THM 700-R4 "UPDATE HANDBOOK"

AUTOMATIC TRANSMISSION SERVICE GROUP

Figure 56

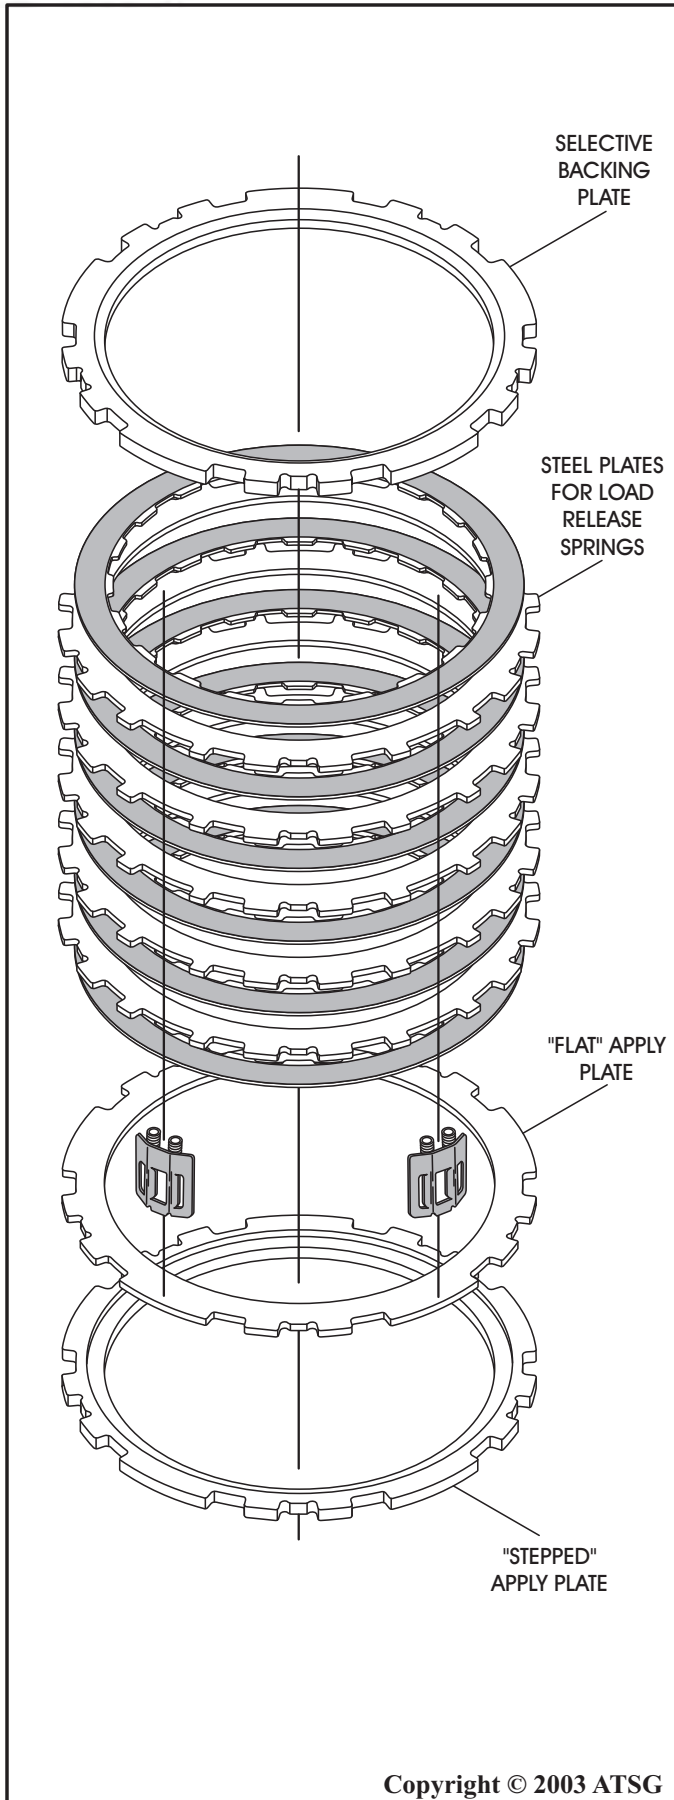
- (1) **LOAD RELEASE SPRINGS** - Added on YDM, YMM, YWM, YZM models only, between the backing plate and the apply plate, as shown in Figure 55. They are located in five equally spaced places around the 3-4 clutch pack, as shown in Figure 57.
- (2) **3-4 CLUTCH STEEL PLATES** - The wide tabs on the 3-4 clutch steel plates were modified to make room for the added load release springs, as shown in Figure 56. However, there is still "One" flat steel plate with the wide tabs required, and is called the flat apply plate. The flat apply plate goes on top of the "Stepped" apply plate, as shown in Figure 56.

Figure 58

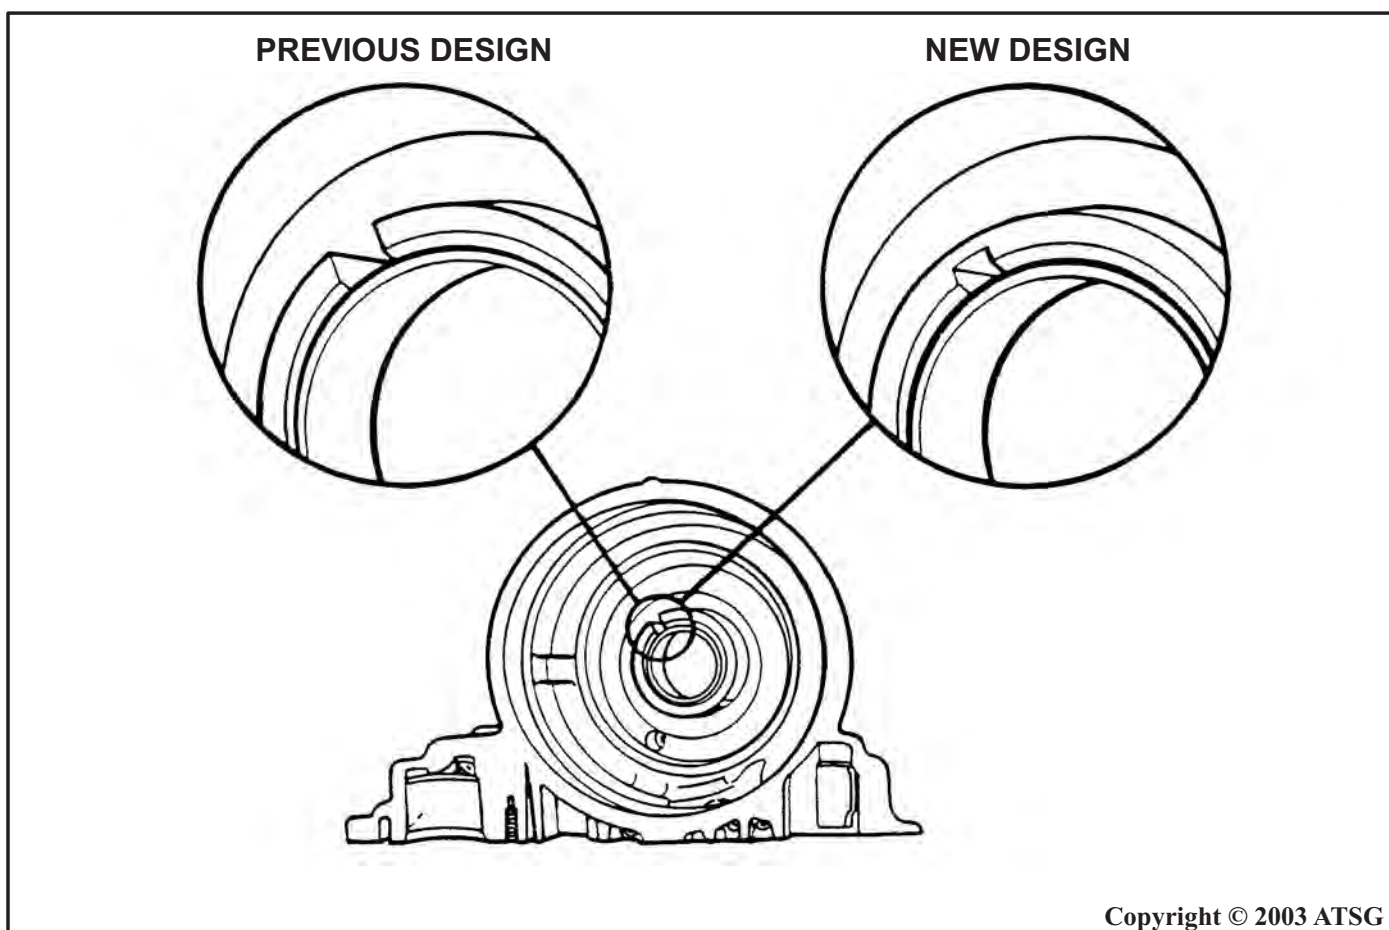
CHANGE: Beginning on February 9, (Julian Date 040) 1988, the transmission case hub, at the low and reverse piston area changed, as shown in Figure 58.

- (1) TRANSMISSION CASE - The slot located in the case hub at the low/reverse clutch piston no longer extends through the hub, as shown in Figure 58. When servicing 1987 and previous model transmissions, it was possible to remove the snap ring with a screwdriver through the slot. With the new design case change, the snap ring *must* be removed with snap ring pliers.

The new design case can be used to back service any previous models.

Figure 59

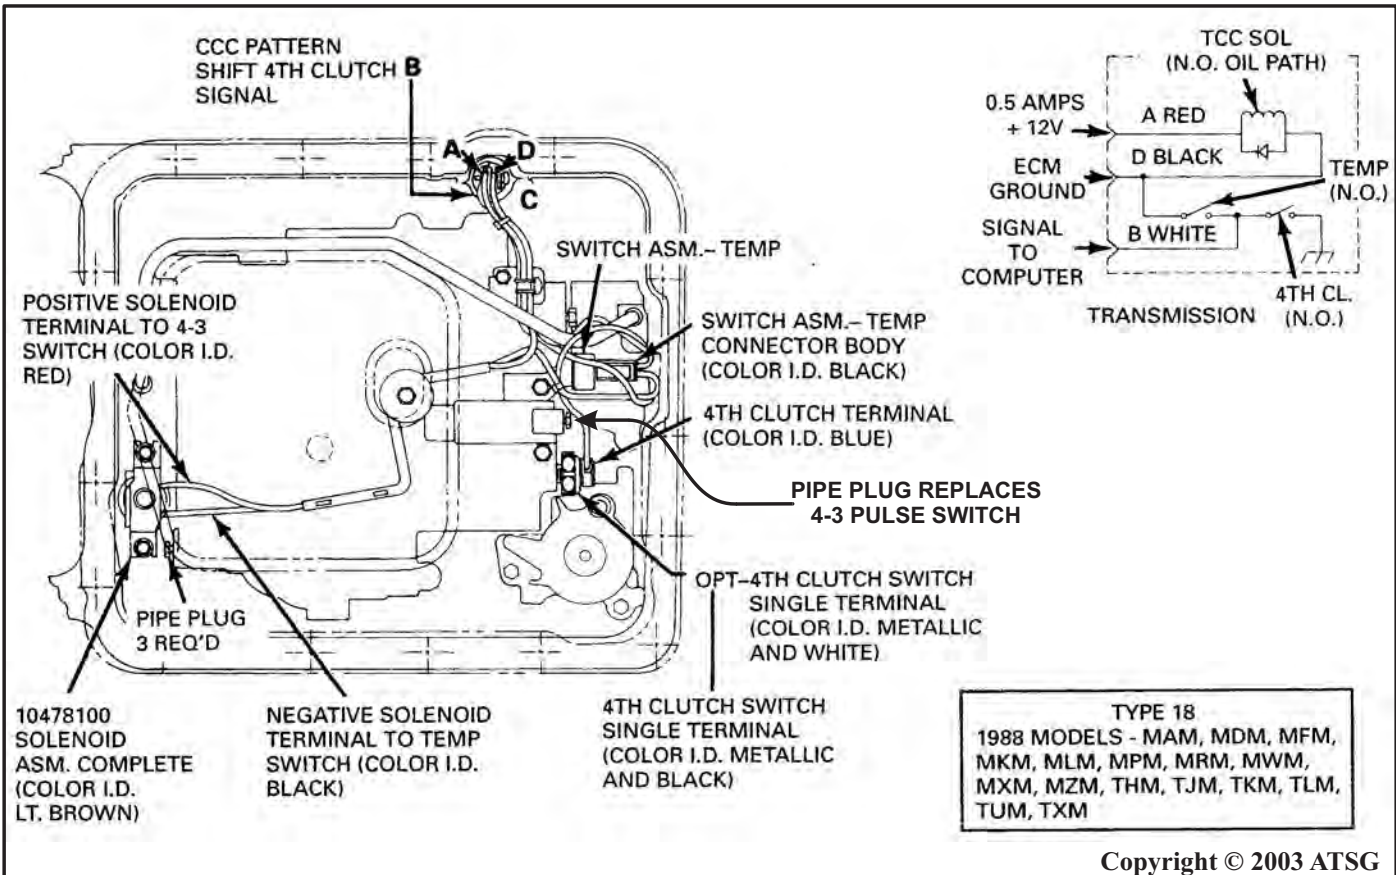
CHANGE: Beginning on May 10, (Julian Date 130) 1988, the 4-3 pulse switch located on the valve body was eliminated, which created a new Type-18 internal wiring harness, as shown in Figure 59. The new Type-18 internal wiring harness was implemented on only the models listed in Figure 59 and replaces the previous Type-15. Refer to Page 54 for illustration of the Type-15 internal wiring harness and the location of the switch that was eliminated.

REASON: The function of the 4-3 pulse switch, to momentarily release the converter clutch during a 4-3 downshift, was programmed into the ECM for the 1988 model year.

- (1) VALVE BODY - The 4-3 pulse switch was eliminated, and replaced with a pipe plug, as shown in Figure 59.
- (2) INTERNAL WIRING HARNESS - Now becomes a Type-18 internal wiring harness with the wires required for the 4-3 pulse switch eliminated, as shown in Figure 59. The new Type-18 internal wiring harness can be identified by the solenoid insulator color, which is Lt. Brown and has 8100 cast into the solenoid insulator (See Figure 59).
